EUROCAE WG49N13 Working Paper WG49N14-04e
Actions () AGENDA Item

MINIMUM OPERATIONAL PERFORMANCE SPECIFICATION FOR SECONDARY SURVEILLANCE RADAR MODE S TRANSPONDERS

ED-73B73C

Draft change proposal ⁱ after WG 49 meeting 14

FIGURE 3-10: ~~LEVEL 1 TRANSPONDER~~: INTERROGATION ACCEPTANCE (3.22.2)

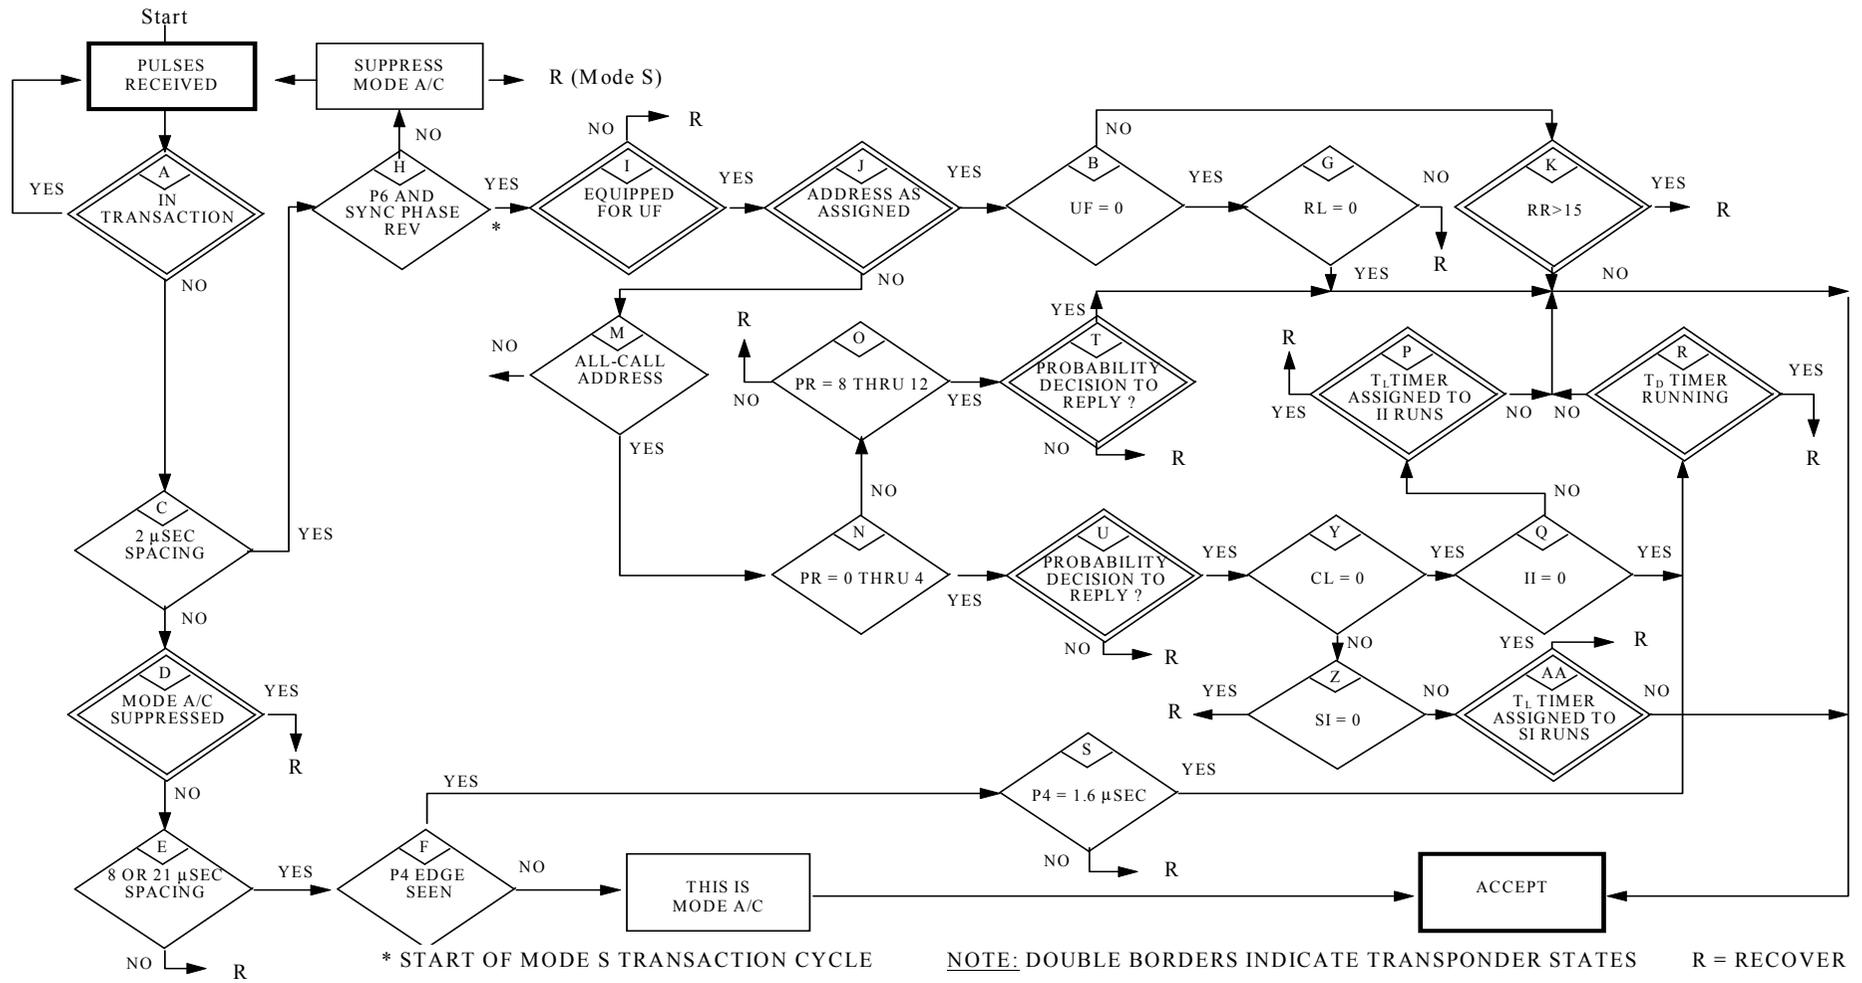
(Figure 3-10 - flowchart, ~~level 1 transponder interrogation acceptance~~)

FIGURE 3-15: DATA LINK TRANSPONDER: INTERROGATION ACCEPTANCE

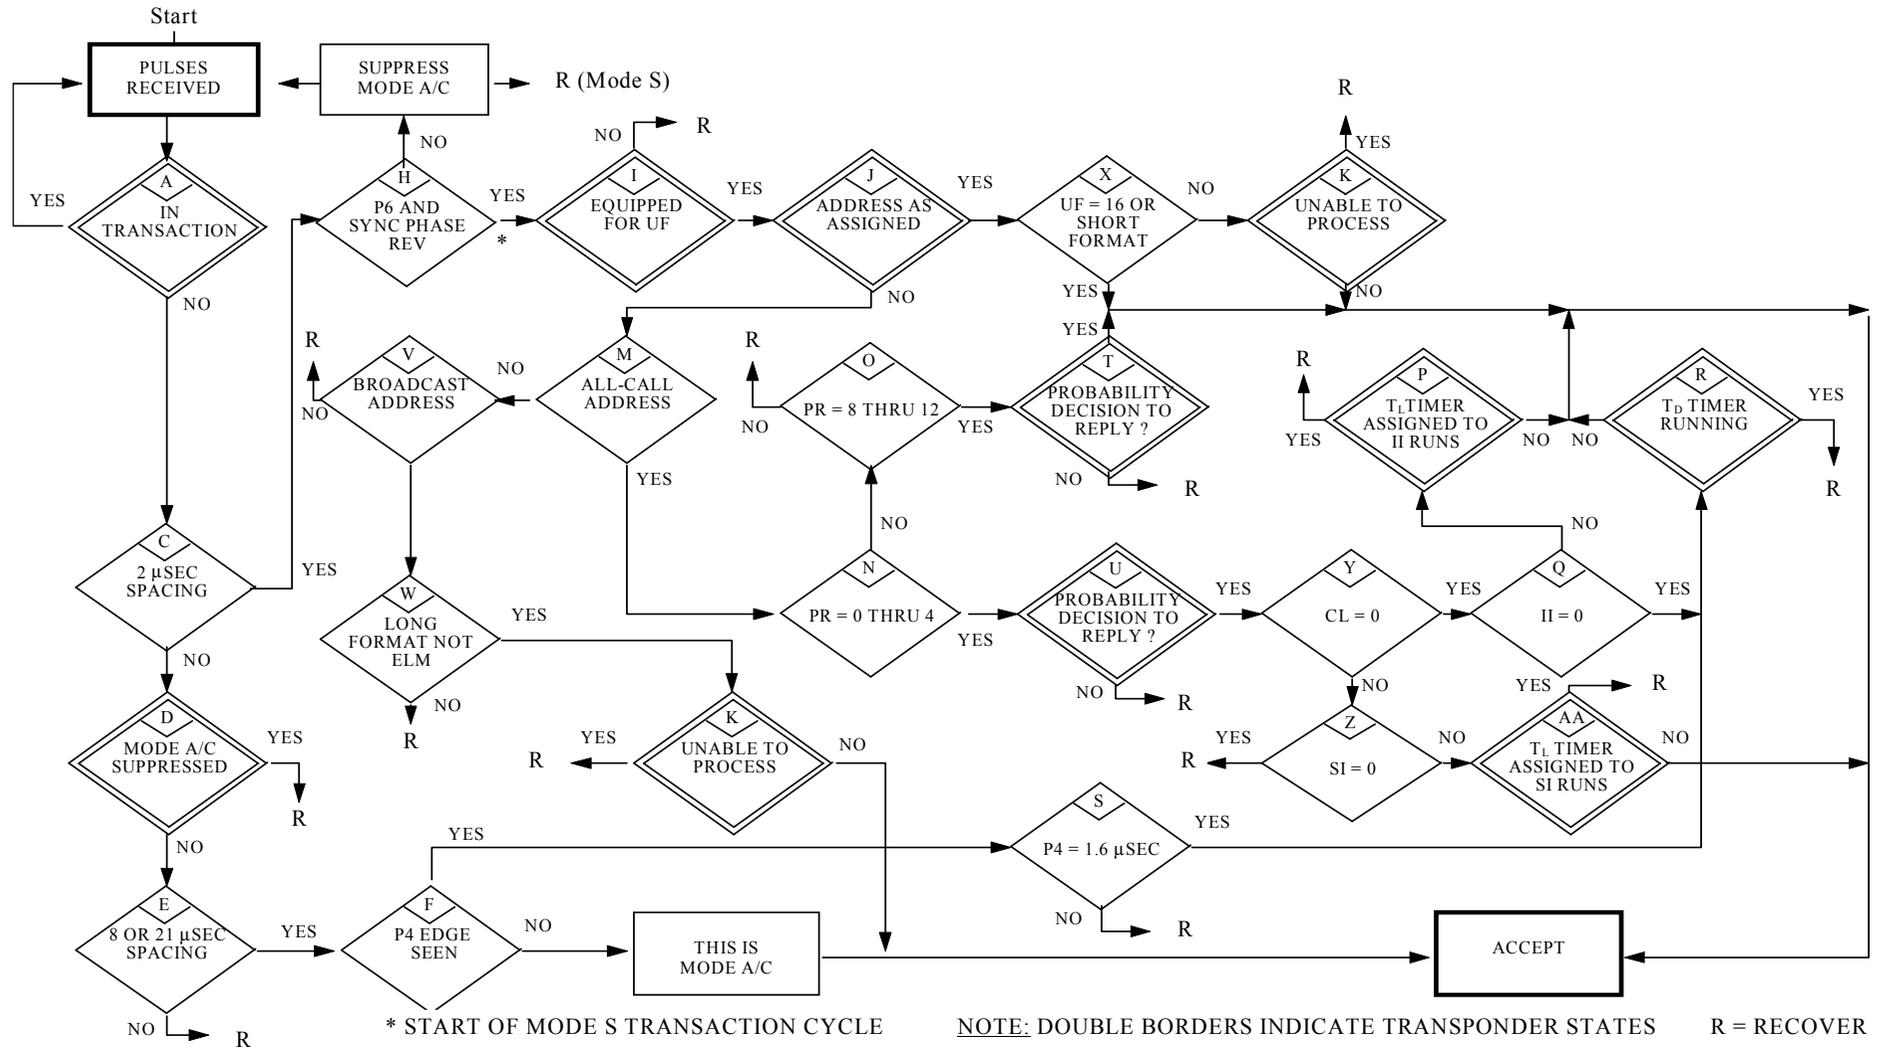
(Figure 3-15 - flowchart, ~~all-data link protocol transponders~~)
